## SSM 72352 - L550 Headliner Modification for Fan Harness

**Models :** LC - Discovery Sport

**Fig 1**

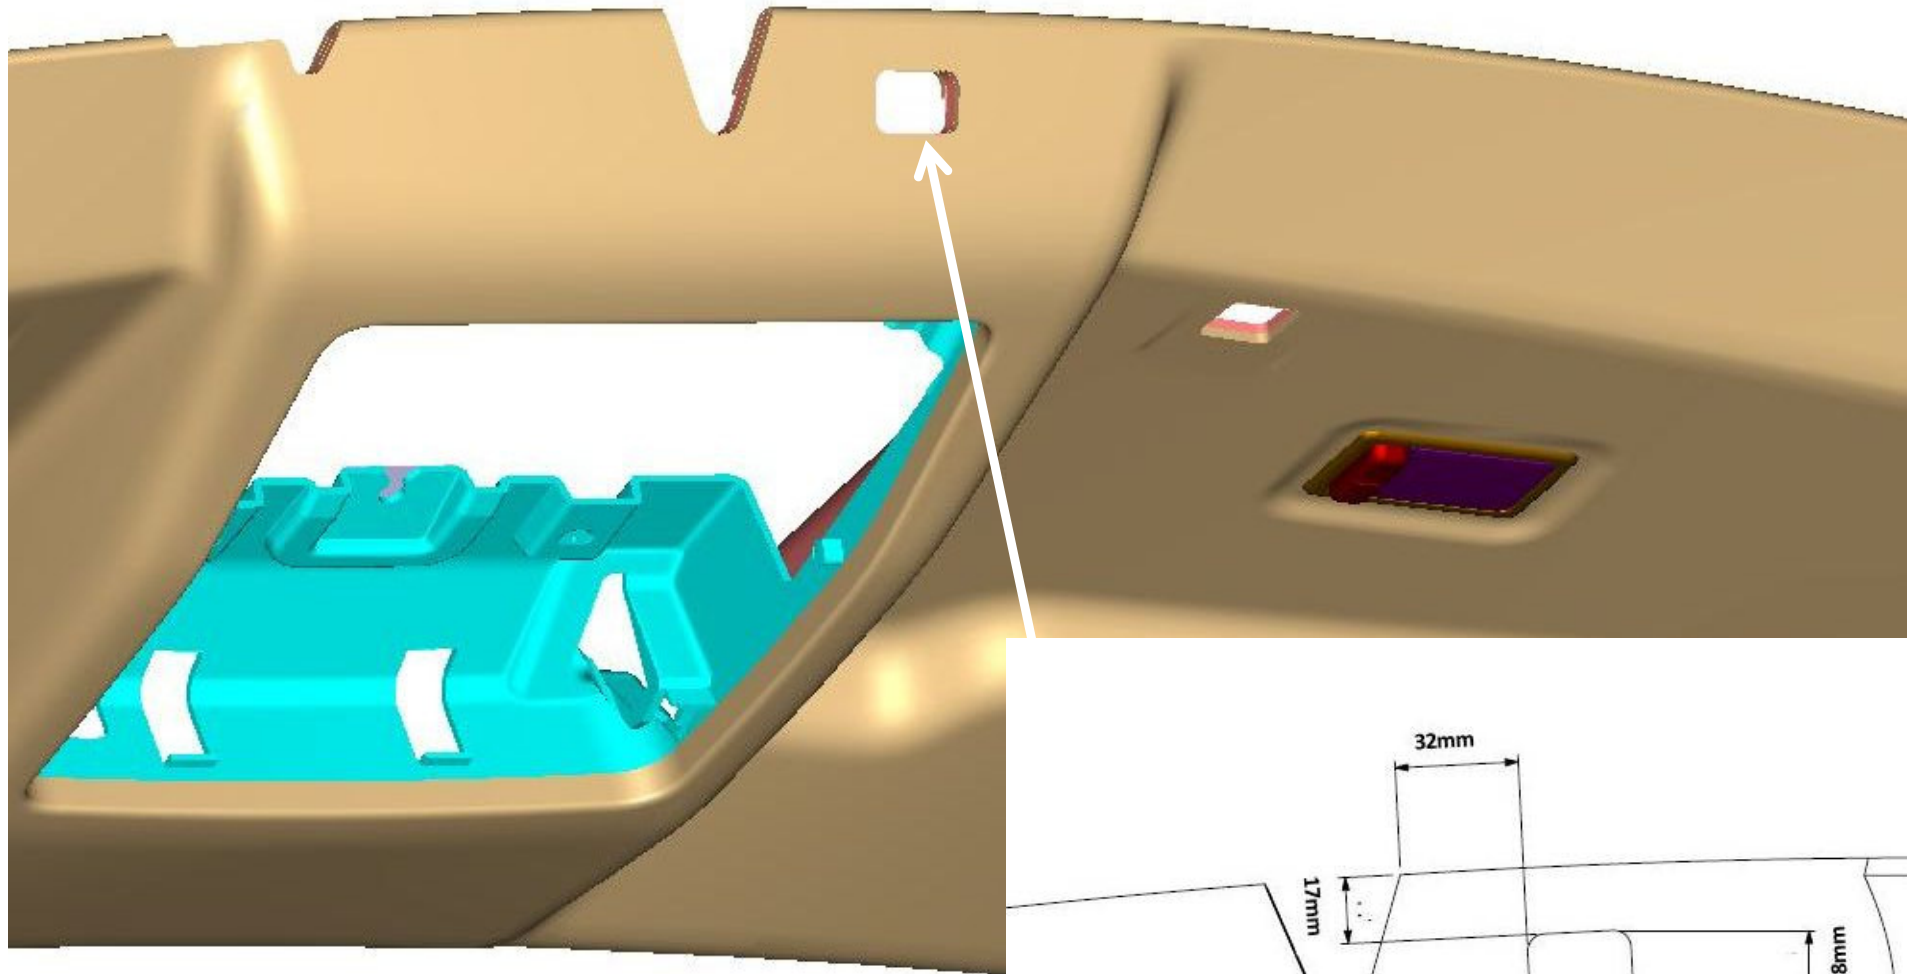
A number of L550 Discovery Sport headlining's have been supplied that may require modification to allow the fitment of the fan harness, by cutting out a square hole in the headlining.

A modification to the part specification after release.

A small square section of the headlining will need to be cut out with a suitable tool (eg. knife) to allow the fan harness to pass through.

- Please see attachment Figure 1, for details and dimensions of the modification required.
- Note: the area will be covered by the body of the rear view mirror when complete - Please see attachment fig 2.
